Peak-to-peak output measurement results and proposal

Comments #82, #93, #94

Adee Ran, Cisco

IEEE P802.3dj Task Force interim meeting, Hamburg

Figure 93-6—Transmitter output voltage definitions

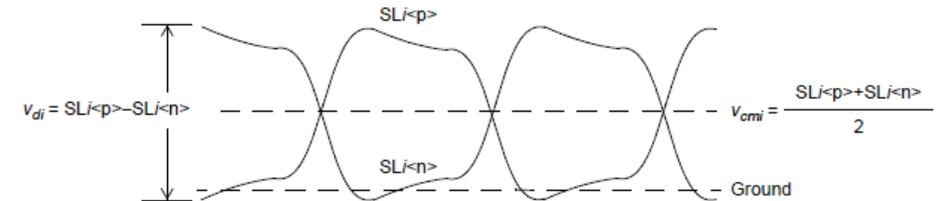
Neither this diagram nor the text around it define the peak-to-peak voltage. The diagram does not resemble a PAM4 signal after IL of >30 dB
